UNIVERSITY OF MISSOURI, COLUMBIA  
MISSOURI UNIVERSITY RESEARCH REACTOR  
LICENSE NO. R-103  
DOCKET NO. 50-186

HAZARDS SUMMARY REPORT  
IN SUPPORT OF AN APPLICATION  
FOR A RESEARCH REACTOR  
JULY 1, 1965

UNIVERSITY OF MISSOURI  
RESEARCH REACTOR FACILITY  
HAZARDS SUMMARY REPORT

FIGURE 9.8 IS

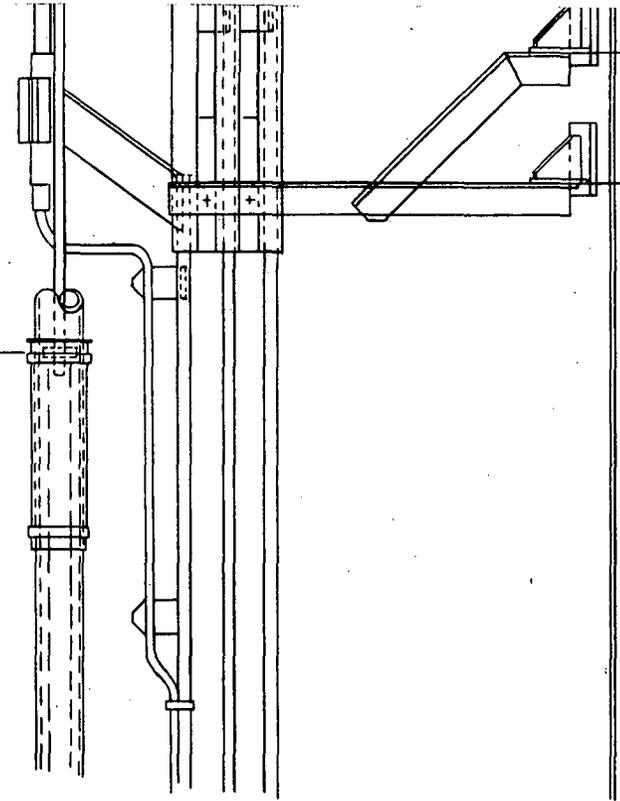
**Delete** Figure 9.8 and **Add** the following note:

"The relative plan view location of the Nuclear Instrument Drywells is depicted by Figure 9.7. Each detector elevation is typically centered on core centerline ( $\pm 6"$ ) and are adjusted as necessary to minimize rod shadowing effects and occasional flooding of beamtubes for maintenance."
